Section 6.3

1 Units of the ADC Compact Digitizer (Overview)

Figure 3

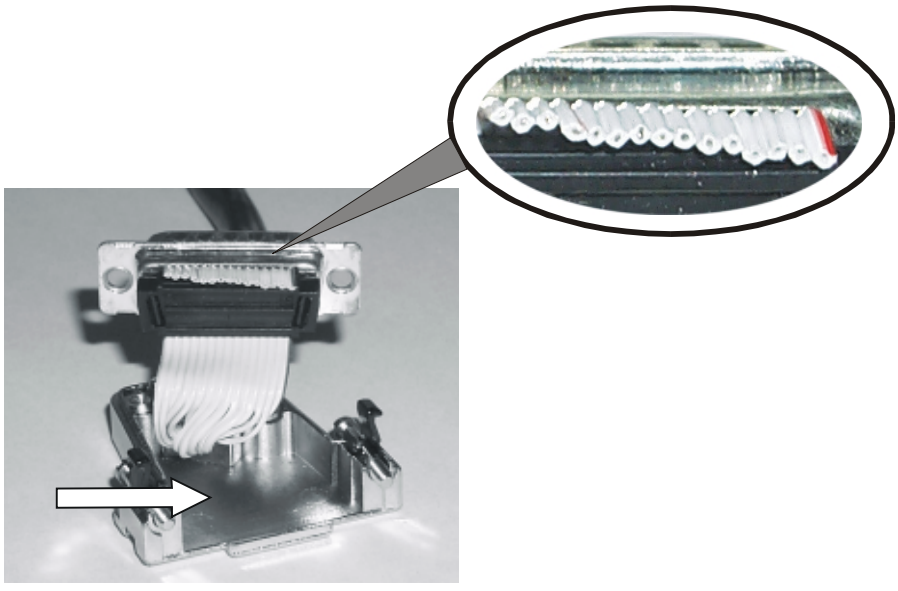
Wires of the ribbon cable (see spot) come into contact with the metal casing of the plug (see white arrow).

Stick a piece of insulating tape to the part of the casing that may come into contact with the blank parts of the ribbon cable (see white arrow).

Figure 5

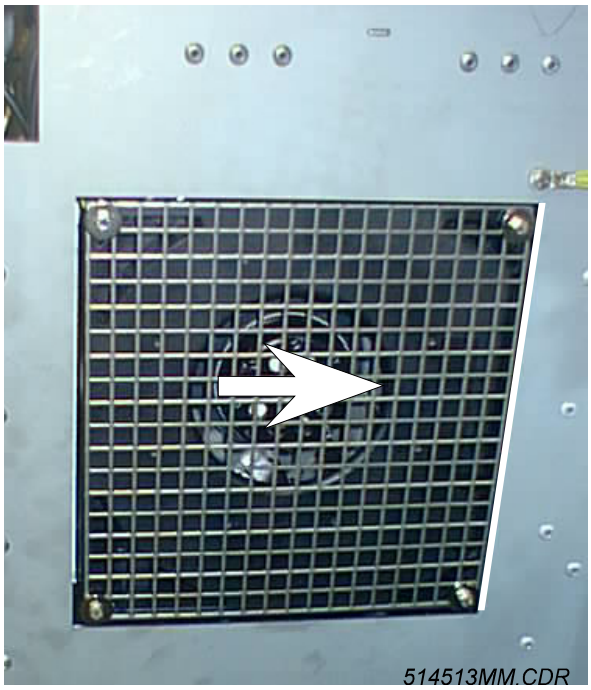
Light may leak in through the vents in the area of the fan of the Erasure Unit (right hand fan edge).

Loosen the fan screws, push the fan and the grid fully to the right and tighten the screws again, see

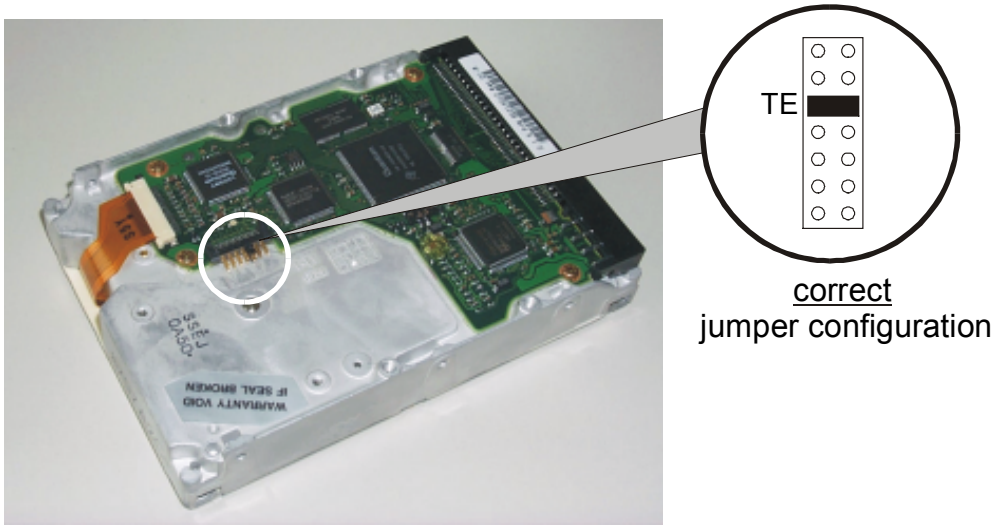
Before installing a new hard disk CM+7.0486.1260.0 after a hard disk crash, check if the jumper configuration of the new HDD is correct.

Due to production reasons the jumper configuration of the hard disks may vary.

The correct jumper configuration is shown in the figure below.

Figure 6

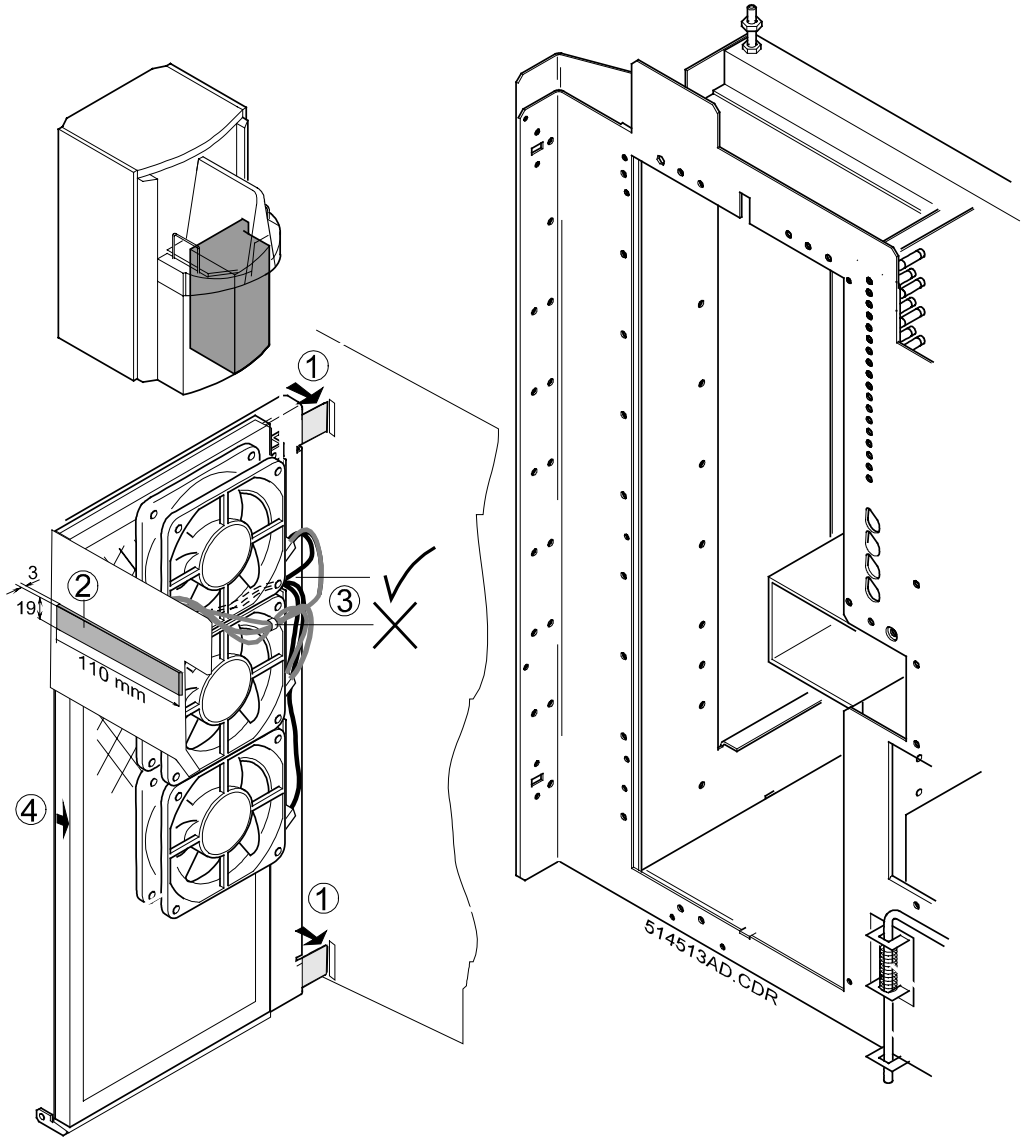
Vibrations at the lug / door slots

Cover plate touches the pump bracket

Fan wiring rubs against the fans

Bend the lugs slightly (approx. 6°) see Figure 6 / 1.

Attach a foam rubber strip (approx. 19 x 3 x 110 mm) at the pump bracket, see Figure 6 / 2.

Place the wires between the two fans, see Figure 6 / 3.

Figure 7

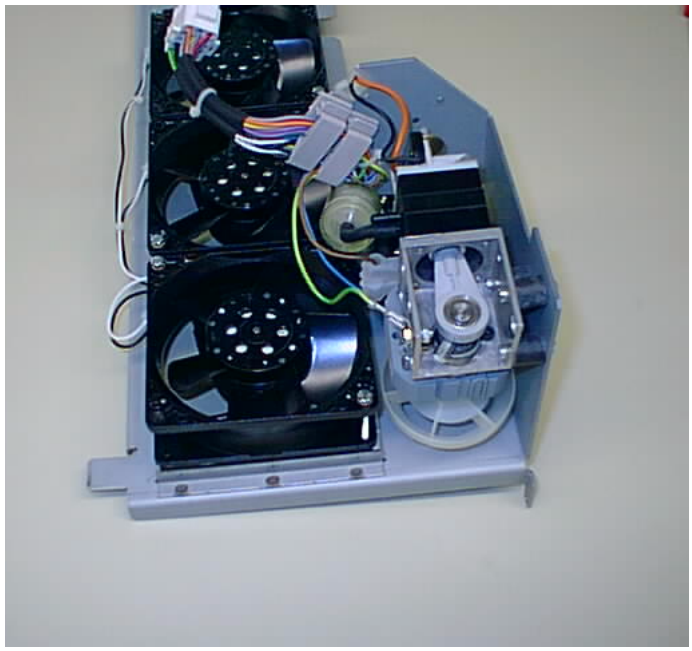
Pump wiring rubs against the fans

Fix the connection cable of the pump with the first clamp, already present, see

Figure 8

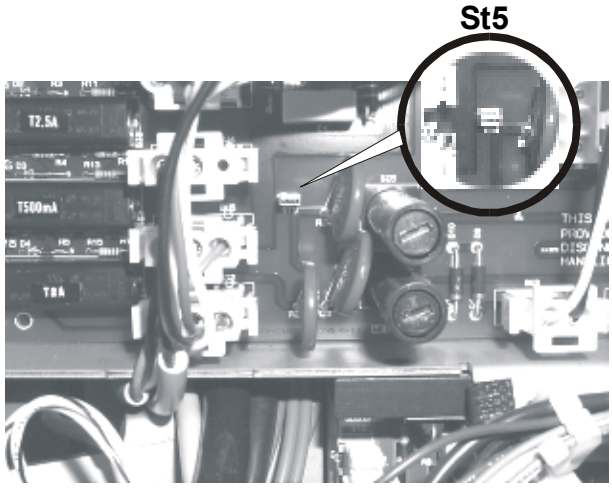
To avoid problems when ADC Compact is being used with IT - ✳ mains remove the jumper on St5 of the Power Unit.

If this jumper is not removed, the varistors may possibly be destroyed.

Figure 9

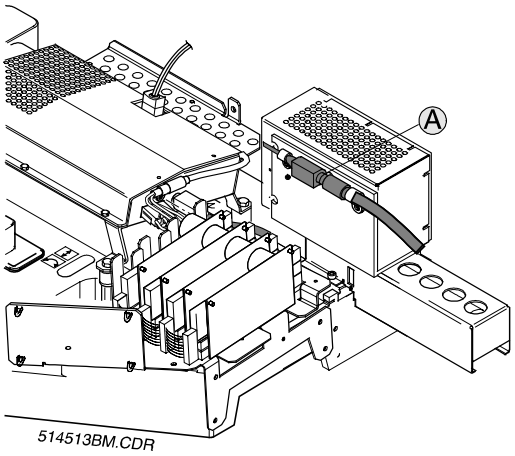
loose plug connection of the pin diode cable (see Figure 9 / A)

Secure the connection with adhesive tape.

Figure 10

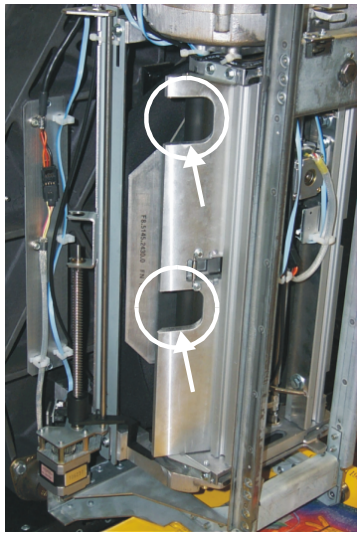
The rear suction arm touches the postscan bar when passing the opening (see circles). The correct suction position is not reached.

Installation of a modified postscan bar with a broader opening for the suction arms (see image beside).

Figure 11

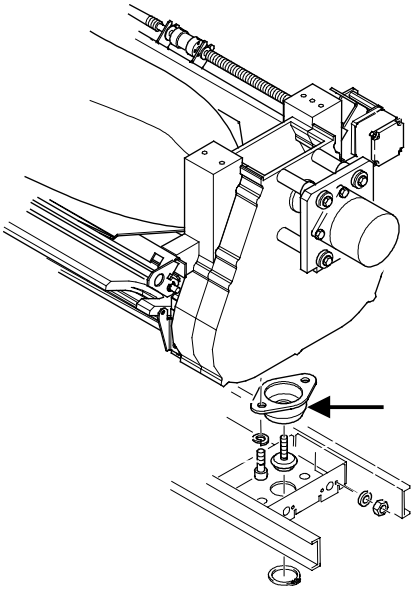
The front rubber buffer (see arrow) between rail and scanner may break down, whereupon the front part of the scanner lowers, the rollers are no longer parallel.

The front rubber buffer is too weak to stand the weight.

The front rubber buffer has been replaced by a new one having the same shape and dimensions but a harder rubber mixture (30 kg).

Figure 12

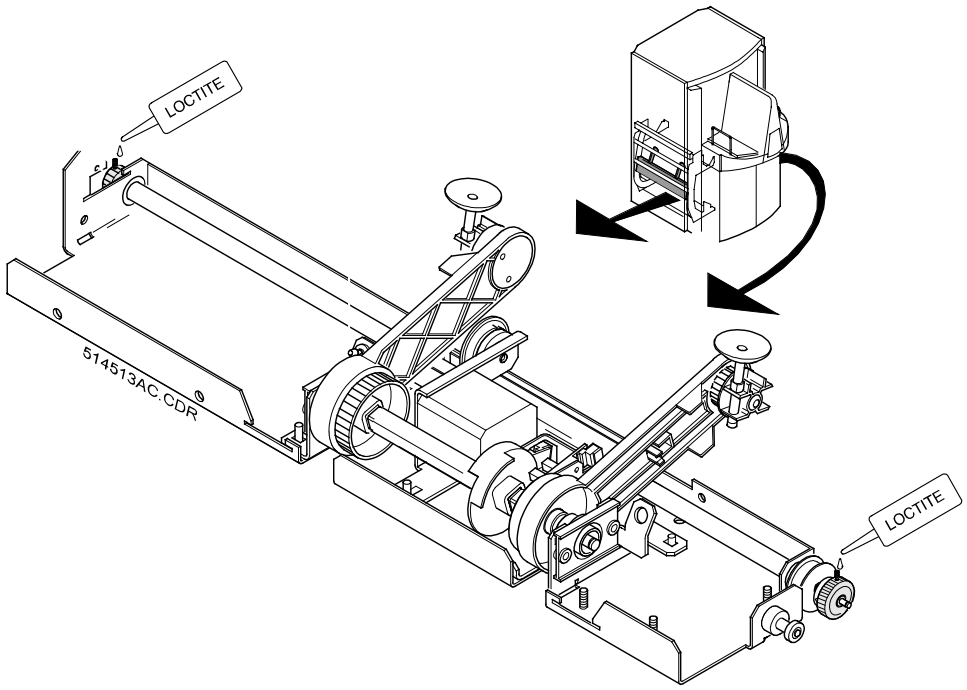
We noticed that after approximately 200 000 plate cycles the set screws on the toothed belt pulleys may loosen and fall out.

Secure the set screw of the 4 toothed belt pulleys (2 x IP-transport unit left, 2 x IP-transport unit right) with screw lacquer e.g. LOCTITE 243. This may be carried out during the next maintenance call.

Figure 13

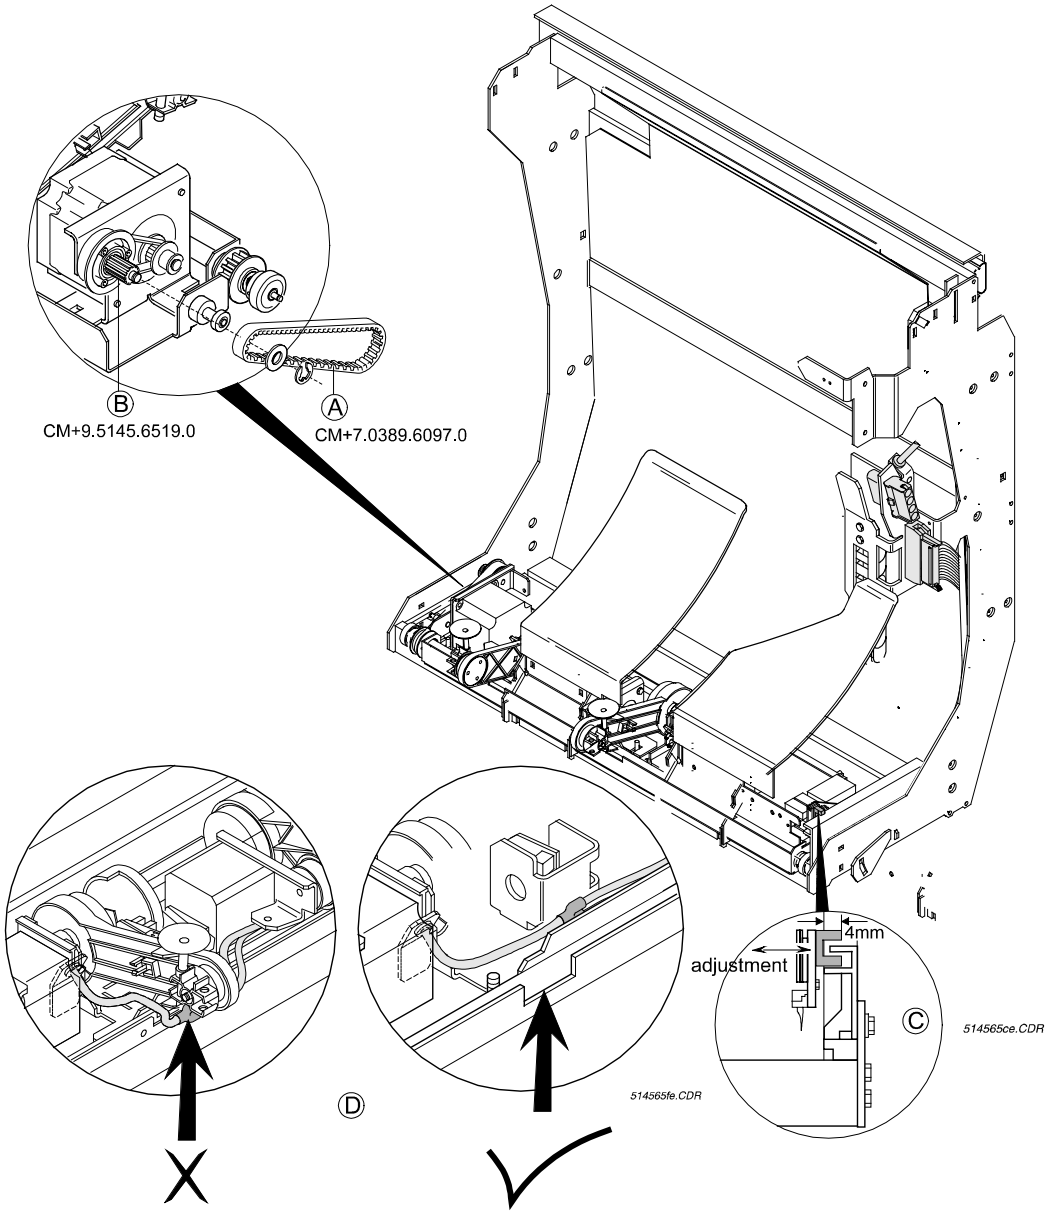
Stretched toothed belt in the IP transport unit right hand side, see Figure 13 / A

Stretched toothed belt in the IP transport unit left hand side, see Figure 13 / A

The light barrier does not run far enough into the toothed segment and thus the ACT. position is not detected. The carriage drives up to the mechanical stop, as a result the toothed belt can be stretched.

Home position of the suction bar (stop on the metal plate) is blocked by the vacuum hose or a cable.

- Replace the toothed belt see Figure 13 / A.
- Replace the damaged gear, see Figure 13 / B.

- Replace the toothed belt see Figure 13 / A.
- Replace the damaged gear, see Figure 13 / B.

- Check the adjustment of the light barrier, if necessary bend the light barrier holder, see Figure 13 / C.
- Replace the toothed belt if stretched, see Figure 13 / A

Position the vacuum hose in such a way, that the suction bar can reach its nominal position, see Figure 13 / D.

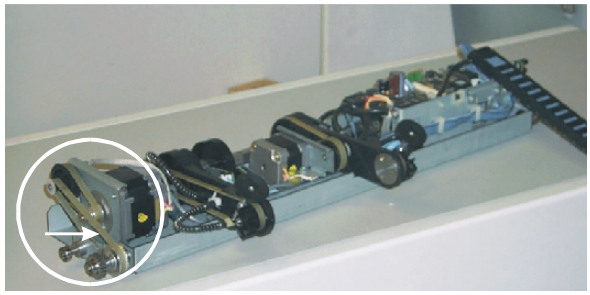
crafty or damaged transportation-belt

Installation of a modified robot:

The robot carriage was revised completely to increase the reliability.

- a spring supported belt - fastener
- new belt-wheels
- beveled belt-disks

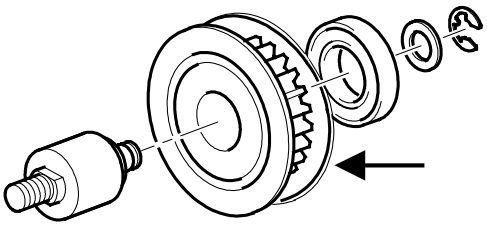
The toothed belt of the cassette clamp may possibly slip from the belt pulley.

The toothed belt has no hold when the humidity of the environment is too high.

An end plate (see arrow) preventing the toothed belt from slipping off has been attached to the axis.

Figure 14

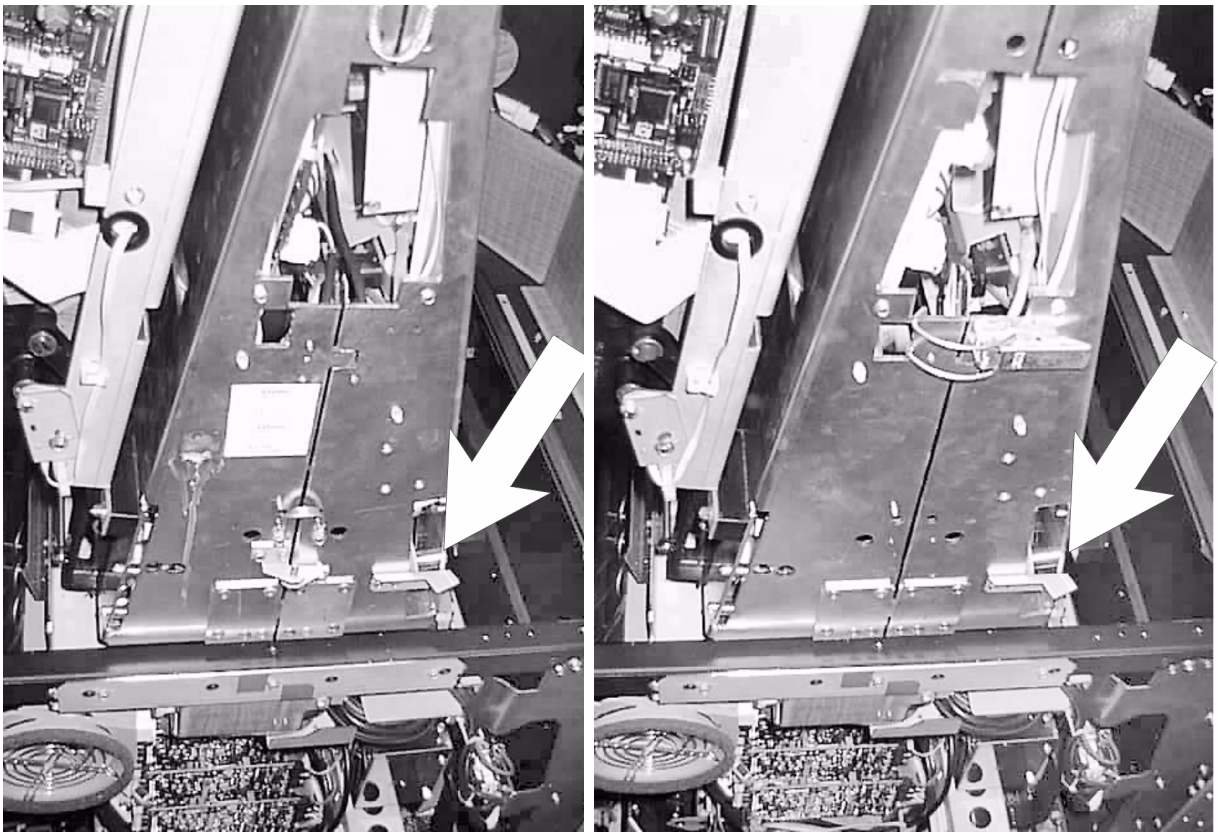
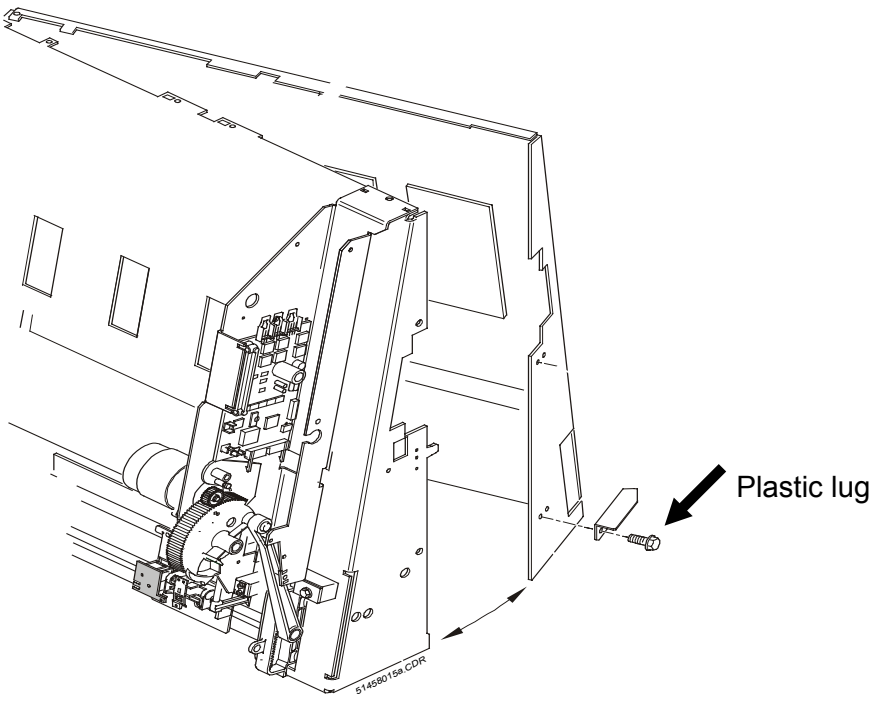
Light shield lug is made of metal and is too narrow.

Replace the metal lugs (2 pieces) by plastic lugs CM+9.5145.5107.3
